PERMIT

SEWAGE DISPOSAL SYSTEM

SUBDIVISION Patapsco Park Estates ROAD 9044 Furrow Avenue LOT 16, Sec. 3

A 30925

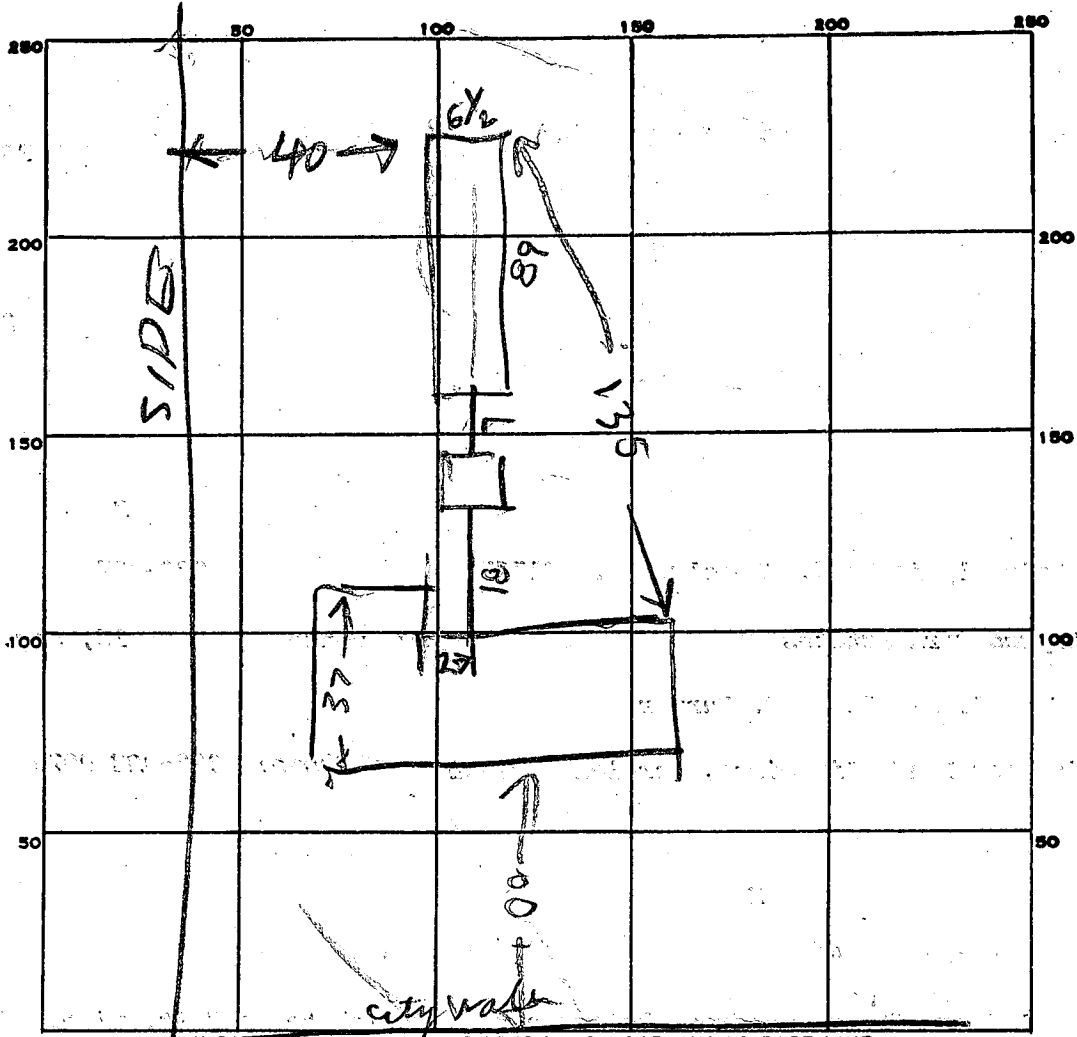
REMARKS 9/6/94 LEACHING BED INSTEAD OF TILE
FIELD AVERAGE 3 1/2 FT COVER OVER BEP
DEPTH OF BED PROBABLY 5-5 1/2 FT STONE
ALREADY ADDED BH Left note stating
That someone should call if they want to change
type of system; Hen Bot Beds & Fields OK

9/6/84 - OK TO HAVE LEACHING
BED HERE INSTEAD OF TILE
FIELD BH

9044 FURROW AVE
LOT 16

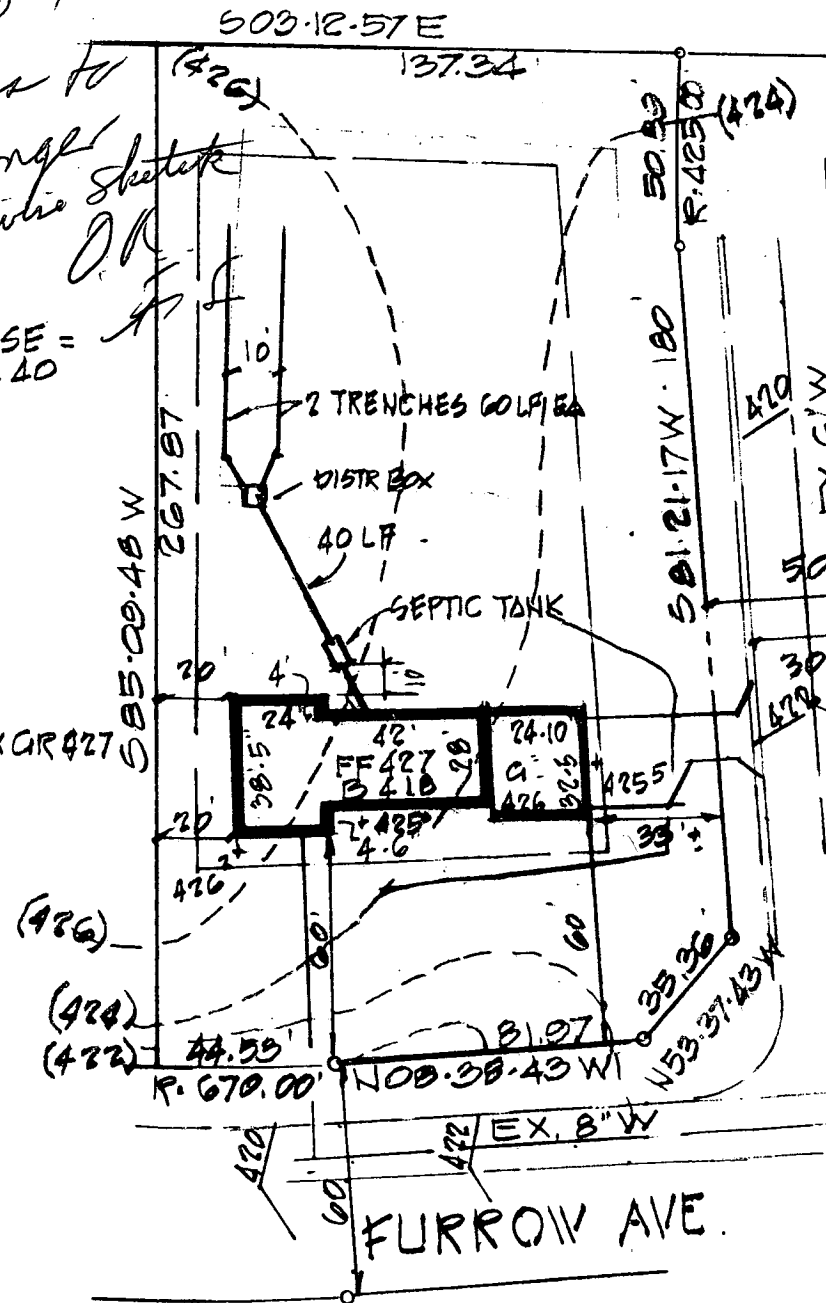
Trenches to
be longer
otherwise sketch
OK
